Bulletin Number - BP2A - 01

Project	Steamboat I	Base Village Re	devel	opment		Date 05/26	/2021	
Project Location	Steamboat,	Colorado				Architect's Pro	ject Number 03.7	835.000
Owner/Client	Alterra Mour	ntain Company	/ Eas	t West Partners	S	File 6BL T	his is page 1 of	
То	Saunders Co	onstruction Inc.				Attention B	ryan Sculthorpe	
Address	86 Invernes	s Place North						
City	Englewood					State CO	Zip 80112 Code	
Delivered via:	П	Messenger	П	Hand carried	П	Facsimile		
Denvered via:		Express		Pick-up		E-mail Address		
		Mail		UPS		Website Address	BIM360	
This Bulletin Convey	s to Contractor (Check one of the fo	ollowing	g five choices.):				
Architect's Author		or Changes to the Work as des	cribed	below.				
		mental Instruction				, ,	ntal Instructions form	•)
Architect's Confir This confirms Archi Note: The above the is/are issued in acco	tect's verbal instr ree choices are ea	ructions to (individu ach subject to the fo	al's nar ollowing	me) on (date g terms: The change	e), a: e(s), clarific	s described below. ation(s) and/or confir	mation(s) described b	RCRBI

General: This bulletin addresses clarifications to Gold Walk's door schedules, door hardware, and room numbering for pe

003.7835.000

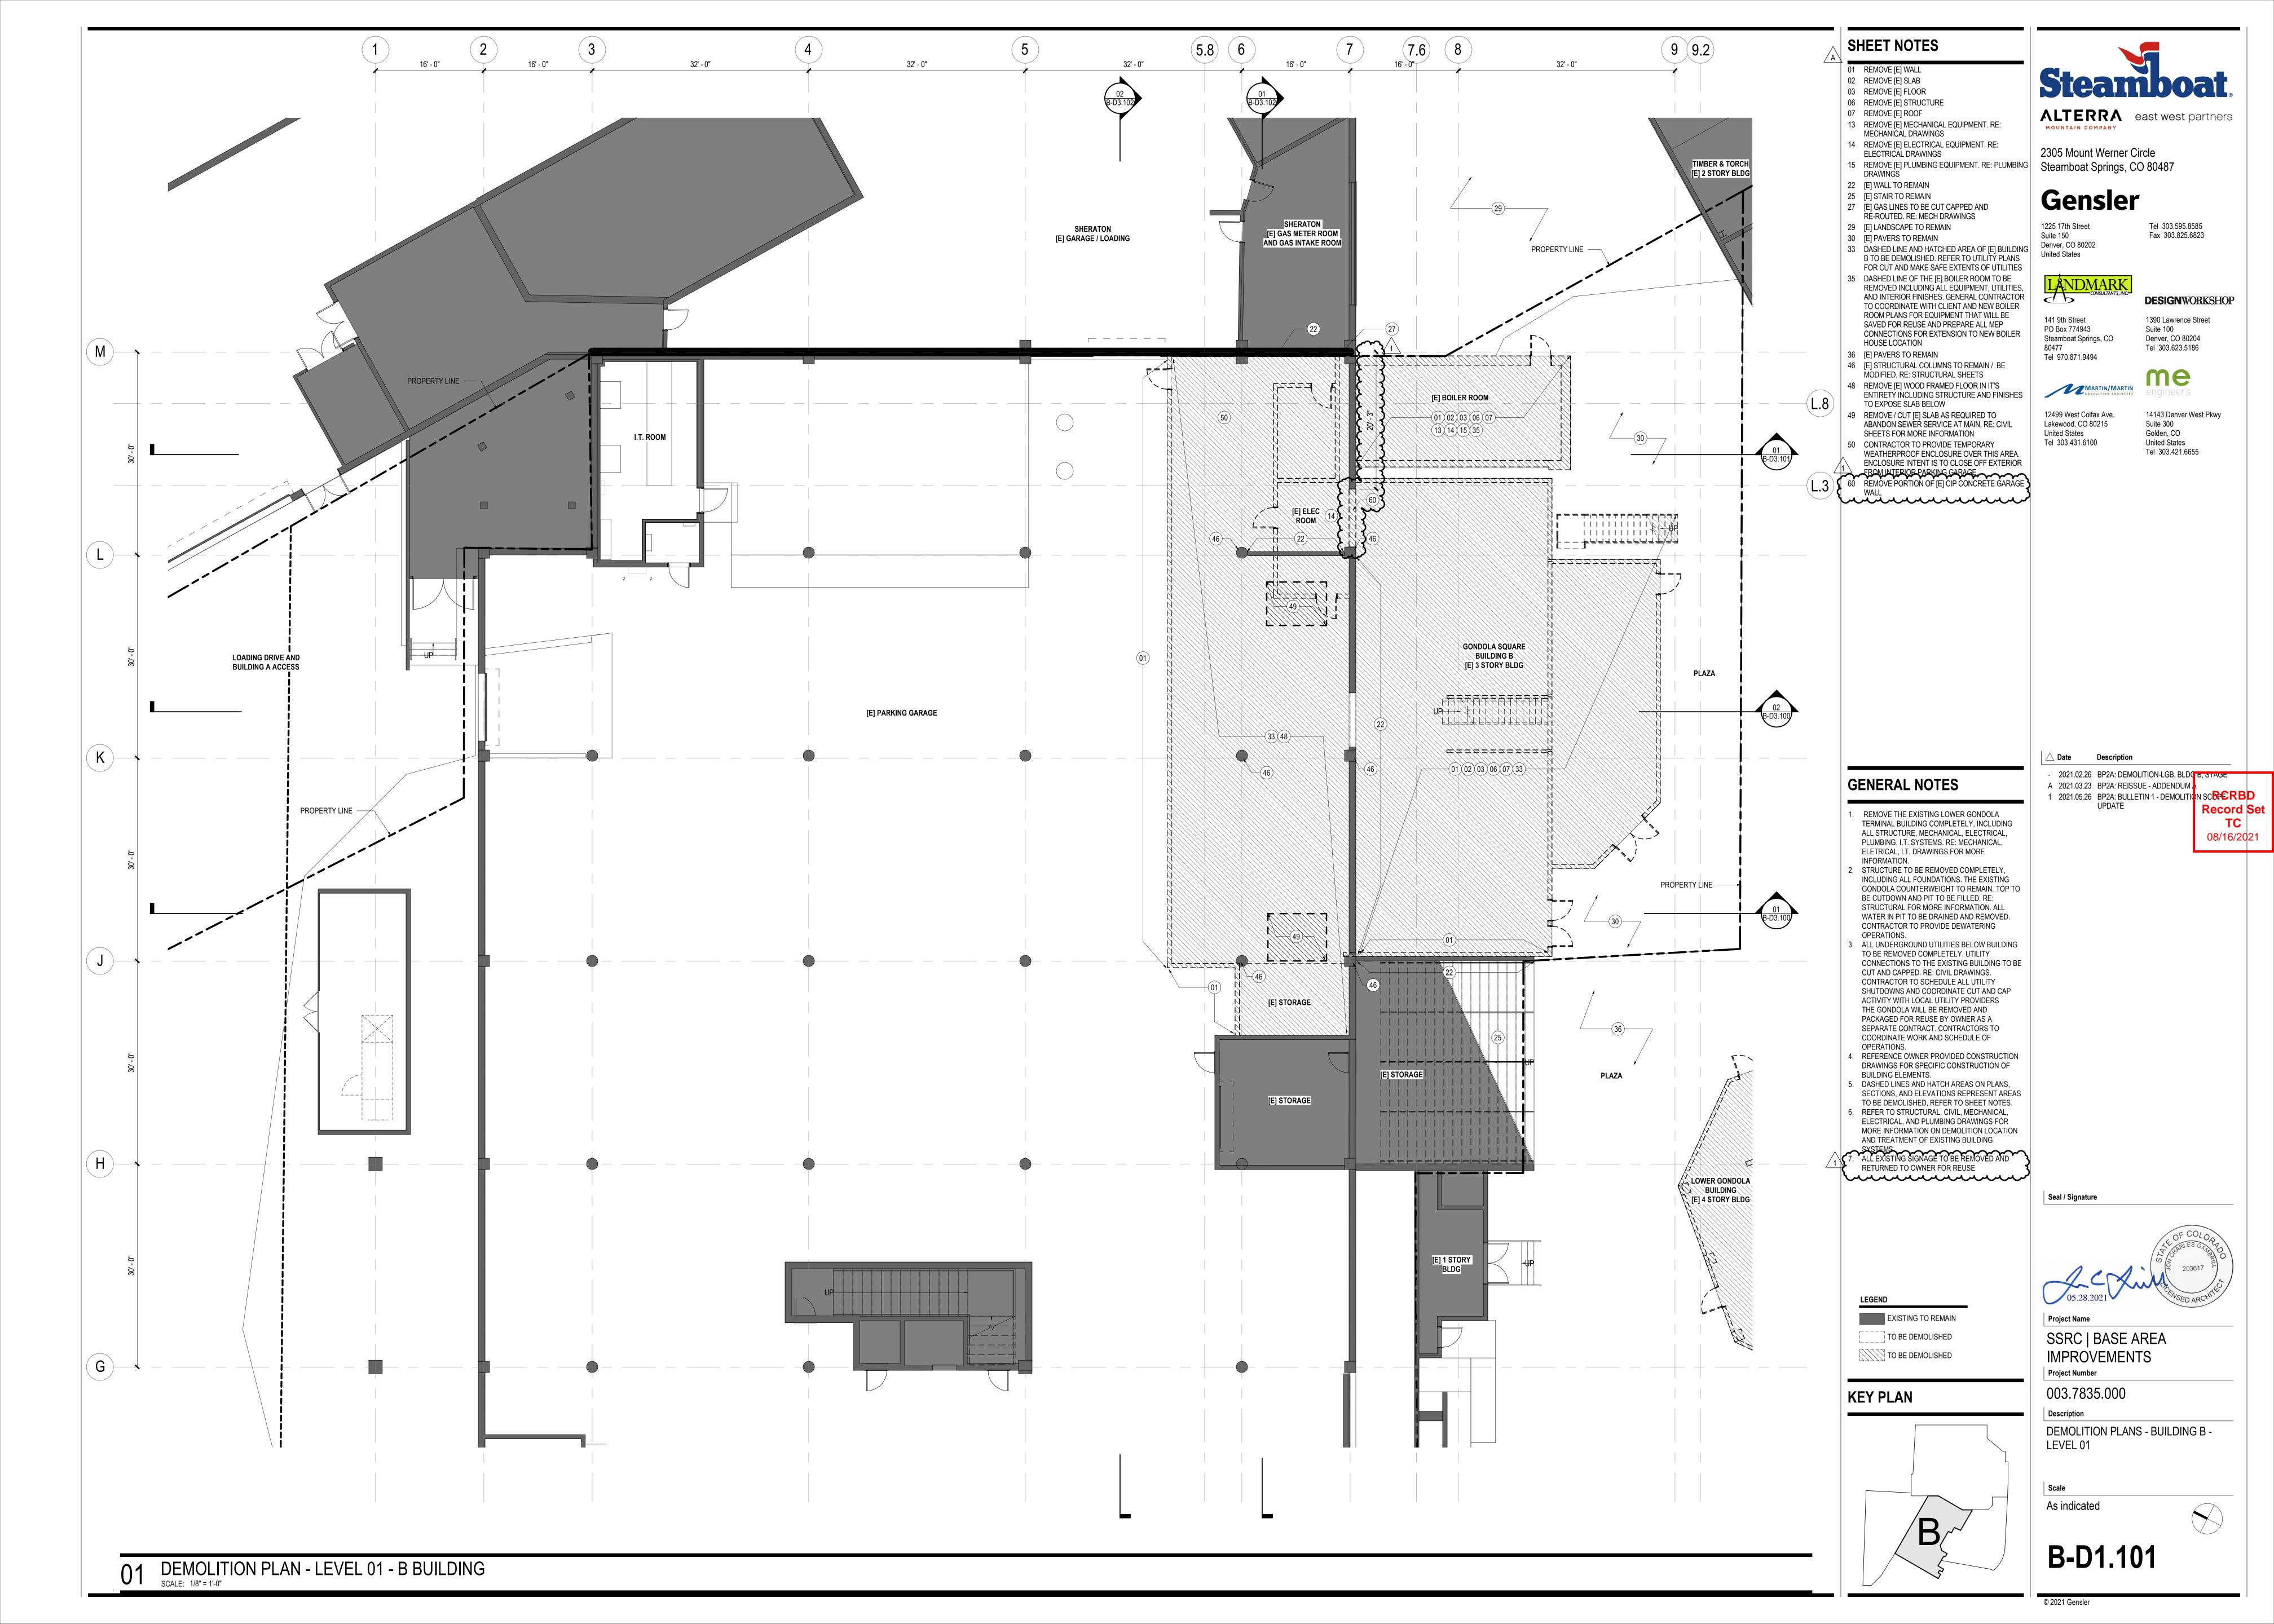
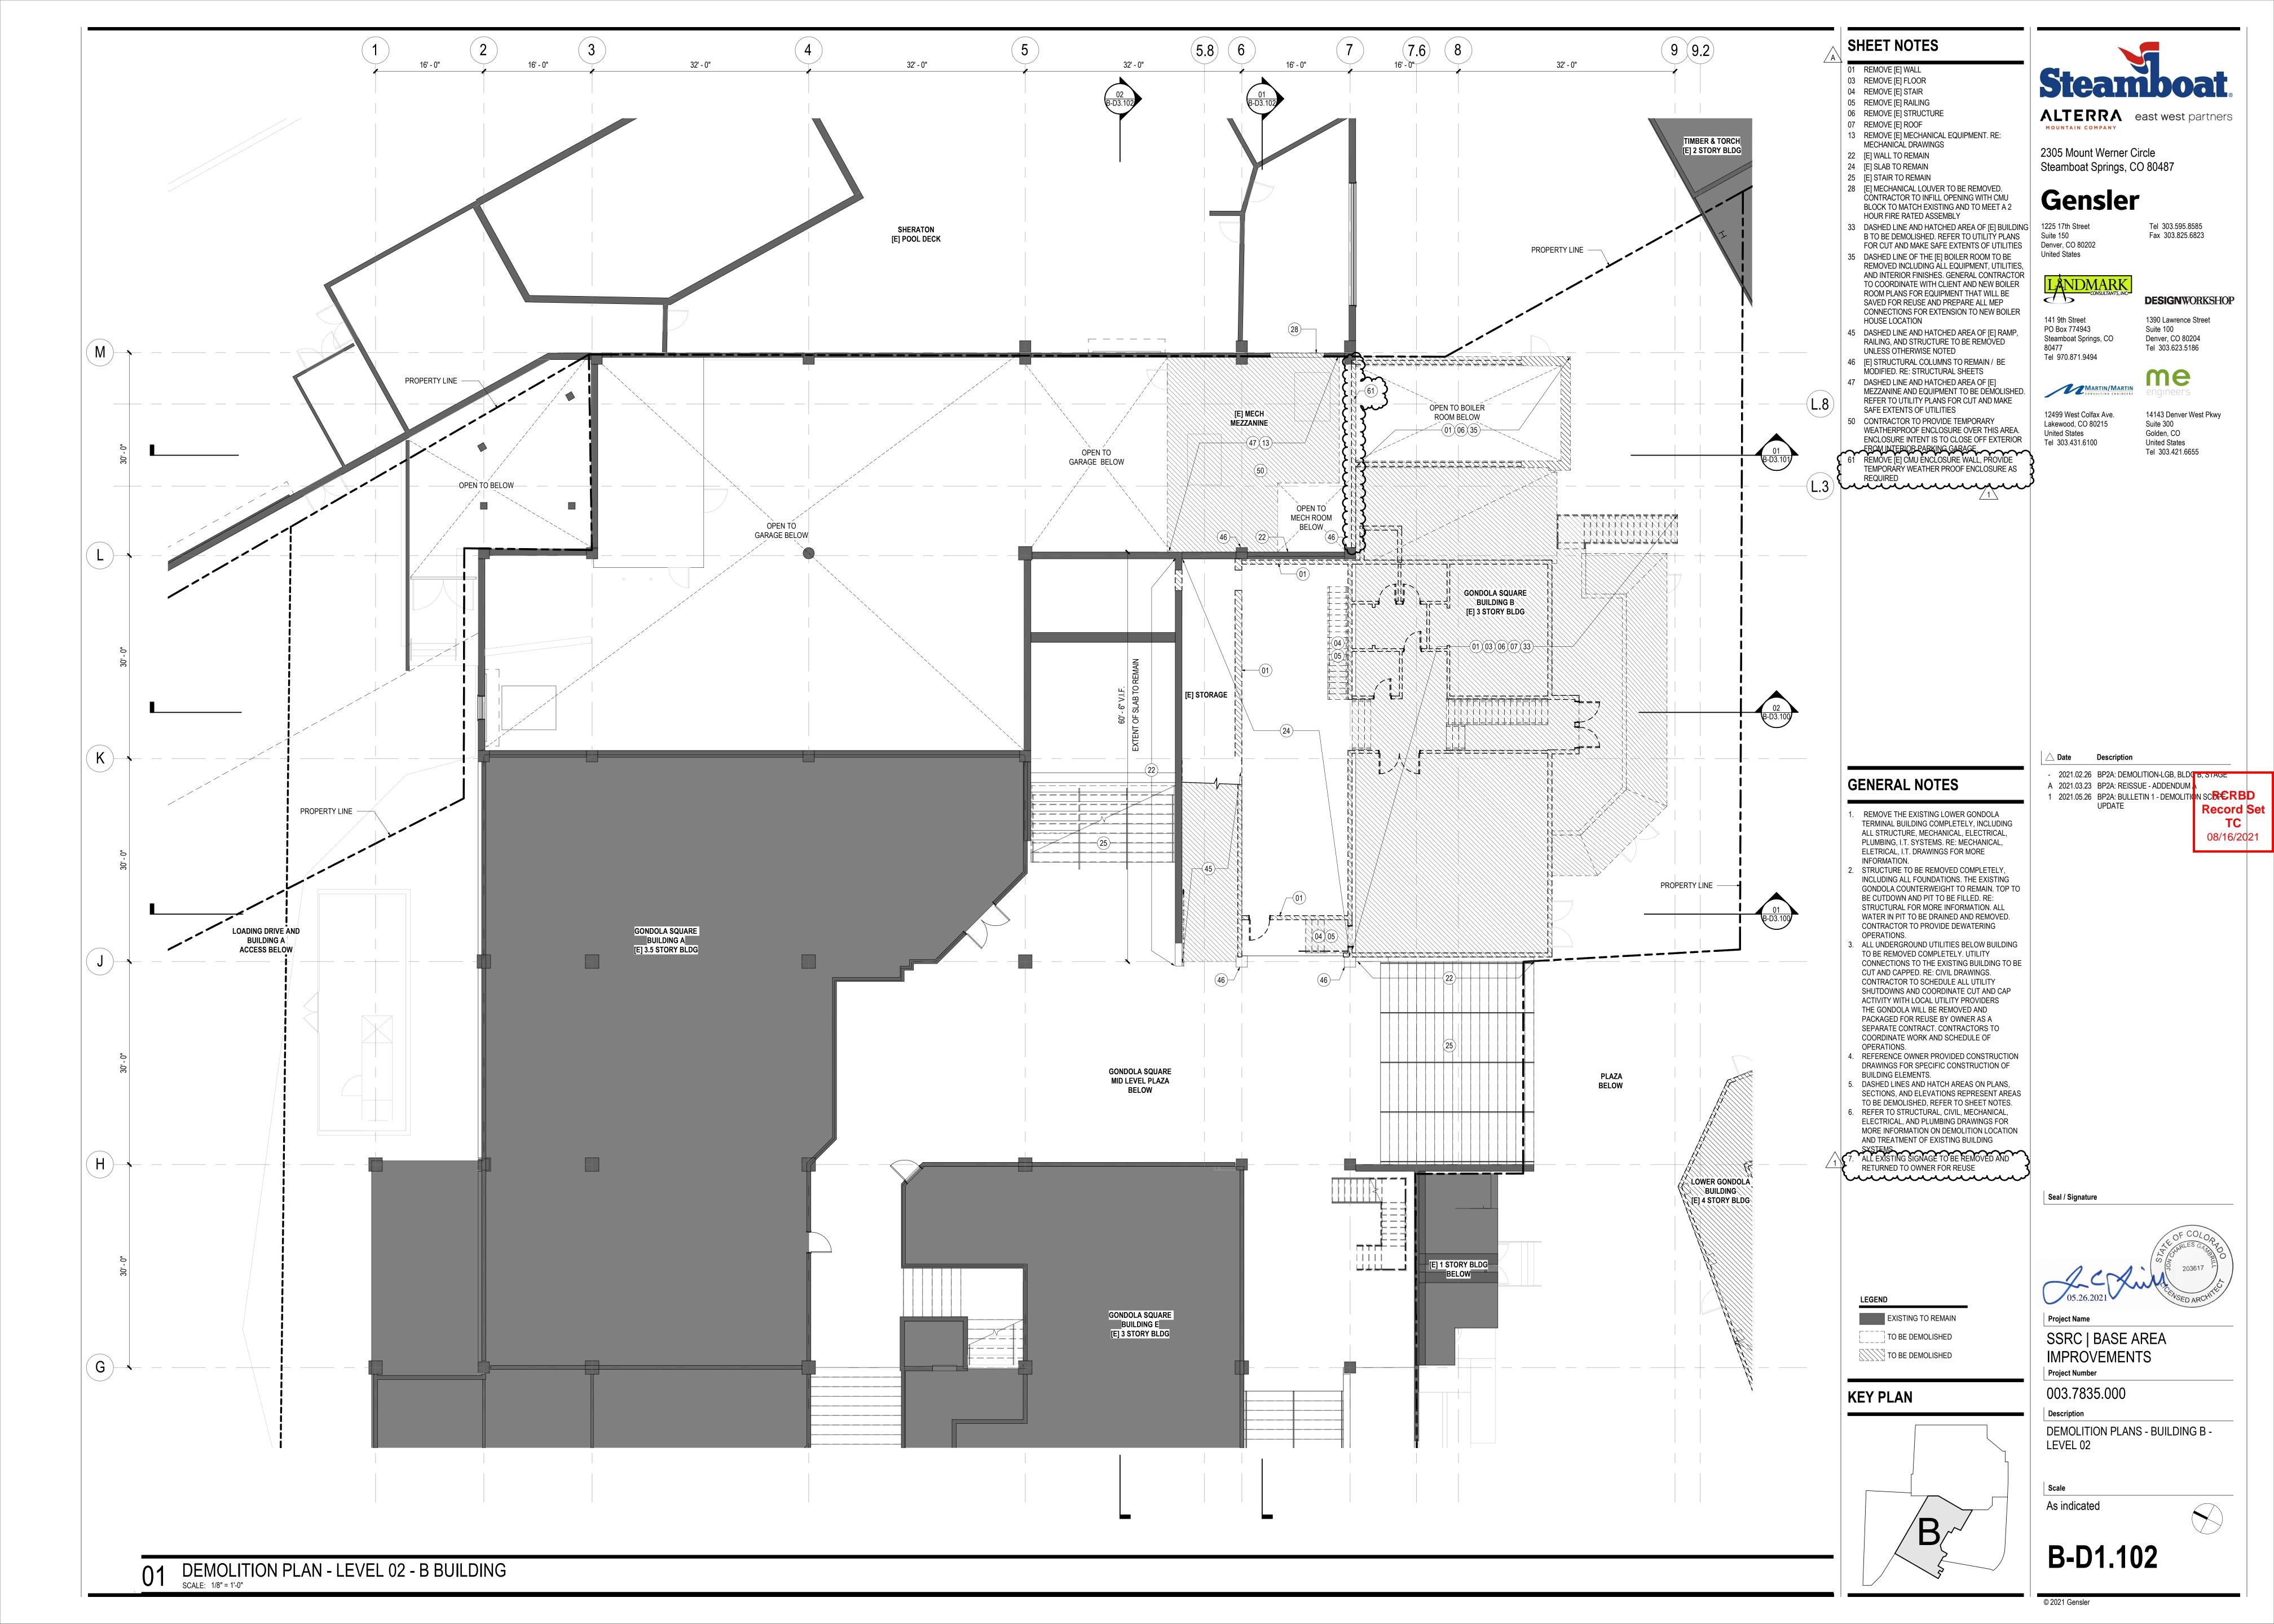
- c. Added Demolition Detail 03, 04 and 05
 - d. Sheet notes Added note #58 and 69
- 5. A-D4.100 DEMOLTION AXONOMETRIC LOWER GONDOLA BUILDING & STAGE
 - a. Axon NW Revised indicated scope

- b. Axon SW Revised indicated scope
- 6. B-D1.101 DEMOLITION PLANS BUILDING B LEVEL 01
 - a. 01 DEMOLITION PLAN LEVEL 01 B BUILDING Portion of garage wall shown as removed
